Technical Service Bulletin

24 Changeover valve for intake manifold flap N316, DTC P2015

24 16 54 2044003/2 May 24, 2016. Supersedes Technical Service Bulletin Group 24 number 16-53 dated April 19, 2016 for reasons listed below.

Figure 2. Routing of fresh air line.

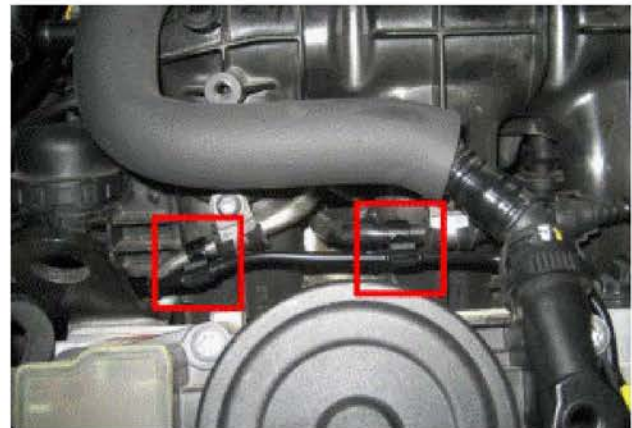
3. Install fresh air line with part number **06H 133 583 F** by first routing it along the cylinder head cover, then securing it with the included clips on the high pressure fuel line and activated charcoal filter cable (Figure 2).
 - **On in-line engines:** Loosen the securing bolt for engine wiring between the second and third cylinder and secure the fresh air line with this bolt (Figure 3).
 - **On transverse engines:** The M6 x 14 bolt with part number **N 107 732 01** (thread-cutting) must be used in addition. Tighten the bolt with 9 Nm +/- 1 Nm.

When routing the clean air line to the intake manifold flap valve, ensure that the clean air line is routed between the cylinder head cover and the vacuum unit lever for the intake manifold flap (Figure 4).
